Isles of Scilly Sea Defences Environmental Statement Addendum

Volume I: Main Text

April 2023

Figure 3-1: updated design drawing for Great Porth (Great Par) North of Great Carn (HR Wallingford, 2023)

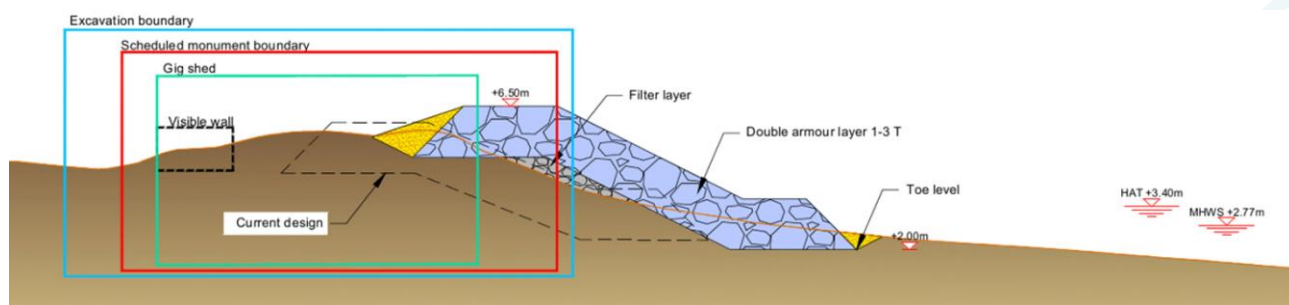
3.2.17 The design of the proposed development at Great Porth (Great Par) North of Great Carn has been altered in response to comments received by Historic England. Comments received relate to concerns surrounding the impact on the Scheduled Monument ‘Gig shed on the north coast of Great Porth, Bryher’.

3.2.18 Three alternative designs were developed by HR Wallingford (2023), each of which with a seaward advancement to reduce or avoid overlap with the Scheduled Monument boundary. The preferred design change at Great Porth (Great Par) North of Great Carn includes the seaward advancement of the structure by 4.1m compared to the original design. Initial discussions have been undertaken with Historic England to address issues associated with the presence of the Scheduled Monument. Full details of this updated design will be subject to the outcome of Historic England’s review of the Scheduled Monument Consent application. A balance is to be achieved between minimising coastal squeeze and avoiding damage to the Scheduled Monument. It will not be feasible to achieve both whilst improving the resilience of the coastline at the site. Therefore preferred mitigation measures, including

3.2.19 In addition, it is proposed that the existing ramp be relocated to the north-west area of the existing location. The revised design will have a greater overall length and volume compared to the current design. Table 3-3 below presents a summary of the key characteristics of the revised design compared to the original design.

Design Option	Seaward advance relative to original (m)	Seaward slope of structure	Depth of toe (mAOD)	Rock size (t)	Crest level* (mAOD)
Original	-	1:2.5	+2.3	1 to 3	+6.0
Revised	4.1	1:2	+2.0	1 to 3	+6.5

Figure 3-2: Updated design drawing for Periglis (HR Wallingford, 2023).

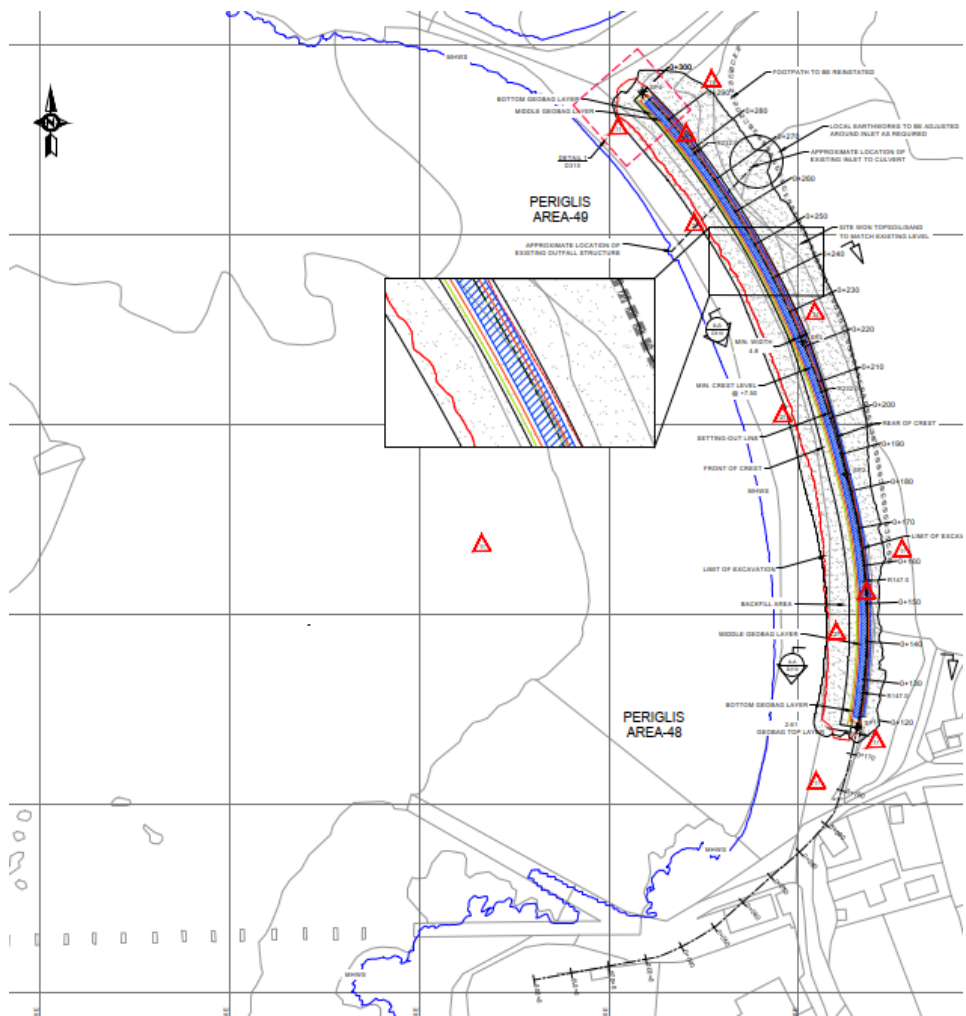
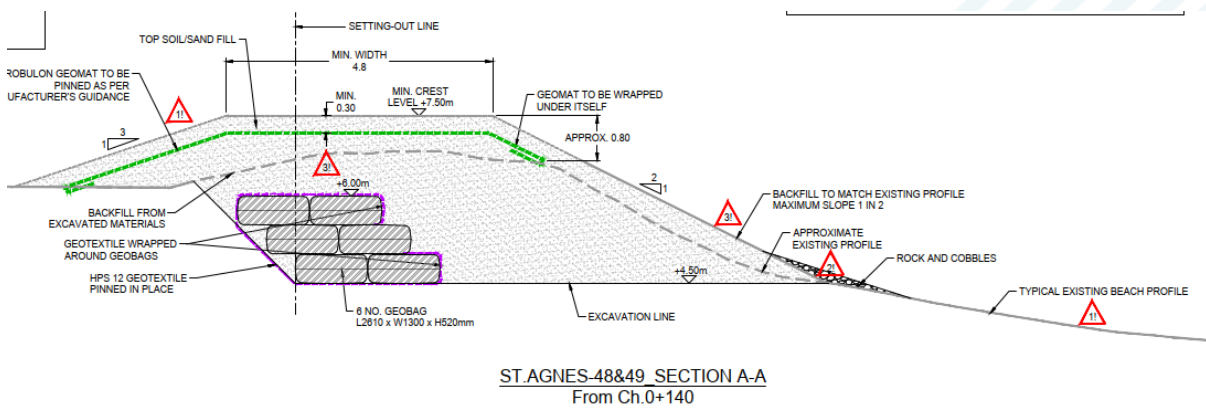
3.2.21 The design of the proposed development at Periglis has been altered in response to comments received by the Environment Agency and Natural England. Comments received related to concerns surrounding the impact on designated habitats and concerns that the design of the proposed works would not provide the intended protection for the drinking water supply and would be prone to undermining and failure in future.

3.2.22 The design has therefore been amended to construct the geobags into the rear of the dune ridge (3m landward) rather than towards the seaward face to avoid disturbance to the shingle ridge frontage and avoid the risk of undermining within the intended design life of the structure.

Figure 3-7: Updated construction access routes across the island of St Martin's

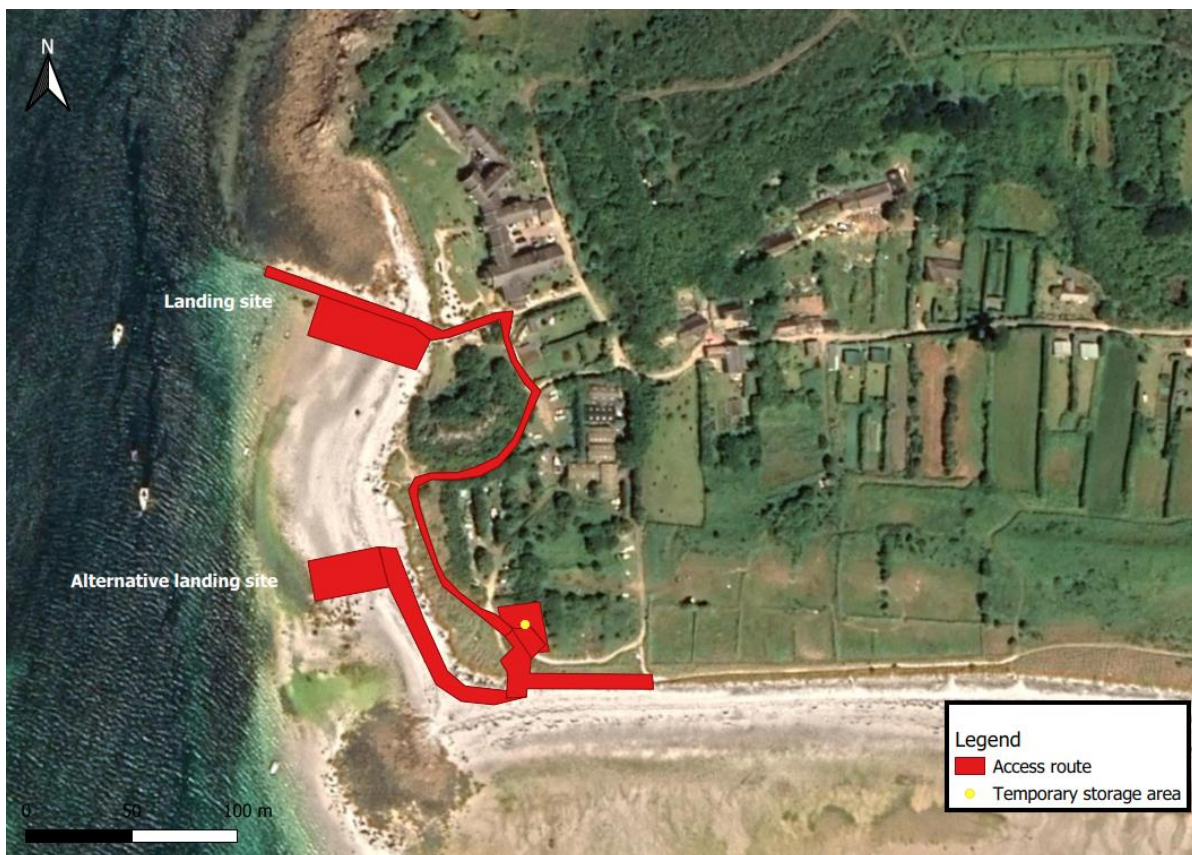
- 3.2.44 All information relating to the transportation of all construction materials and welfare units to the islands and across the islands remains valid. It is anticipated that delivery and construction of the beach access ramp and dune fen will be undertaken over approximately 7 days in April.
- 3.2.45 Figure 2-30 included as part of the submitted ES showed the access routes, landing sites and temporary storage areas for construction of the proposed schemes across the island of St Martin's. Figure 2-30 has been updated to reflect the updated red line boundary for St Martin's (See Figure 3-2), removing the Seven Stones track and Seven Stones rock pile since material stored there will no longer be used across the sites.
